Victorian Society Testimony for October 29, 2024: 891 St. Mark's Avenue (LPC-24-08616); 2103 Albemarle Terrace (LPC-25-01542); 70 Perry Street (LPC-25-02666); 48 Barrow Street (LPC-25-02527); 327 Bleecker Street (LPC-25-03133); Morningside Park Staircases (LPC-25-01988)

Approximate time: 4:15; join Zoom by: 3:15 LPC-25-01988 -- Morningside Park - Scenic Landmark, Manhattan

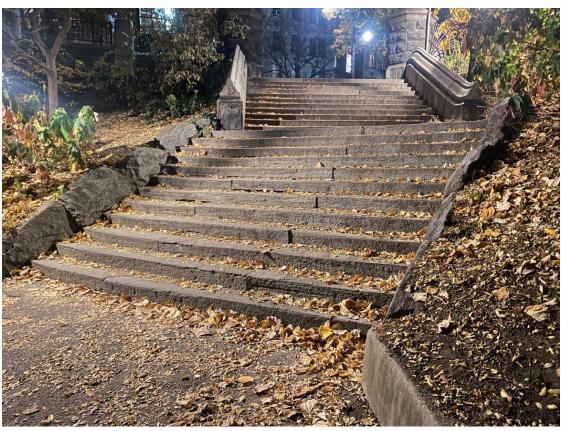
The staircase at 122nd Street was once an example of the extraordinary stonework that Calvert Vaux and Jacob Wrey Mould achieved in Morningside Park. The pictures provided with our written testimony show that the upper flight of the stair retains Mould's formal design at Morningside Drive, which transitions beautifully to a flight of Vaux's rustic stair with its cut boulder edges. Below this point, most of the stair was reconstructed in the mid-20th century and is nothing like the original. This part of the stair includes concrete landings and a long section with cheek walls made of small, rectangular cut stones laid in regular courses. The proposal to match the inappropriate appearance of these later walls by installing blocks of thin stone veneer on concrete is utterly inappropriate to this historic park. The stairs should be rebuilt to match the design and character of Vaux's original rustic stone staircases. Irregular boulders and/or larger rustic blocks of stone can hide the necessary concrete retaining walls.

The handrails proposed for all three staircases are inappropriate in both placement and design. Handrails and posts placed at the outer edges of the stairs will intrude into views of the rustic stonework and landscape. We do not think there is a need for two handrails on these lightly used stairs. A single handrail in the center of the staircase will be much less intrusive. Central handrails are common on staircases of this width. Depending on the height and details of the edges and cheek walls at each stair, wall-mounted handrails could also be an unobtrusive option.

The simple, square-sectioned railings shown in the proposal are not harmonious because of their sharp contrast with the soft, undulating, irregular nature of the stonework and plantings. The railings need not be elaborate, but they must be stylistically compatible.

Mould's formal staircase at Morningside Drive (top); the remaining flight of Vaux's rustic stair (bottom). Vaux's work should be replicated at parts of the stair proposed to be reconstructed. Imagine how modern, rectangular railings at the stair edges will adversely affect the scenic character. A single, center rail would be less intrusive.

Note the brilliant transition between formal and rustic and the way Vaux cut the boulders to fit the stair treads.

Positive report 8-0 (Goldblum and Jefferson recommended a single center handrail).
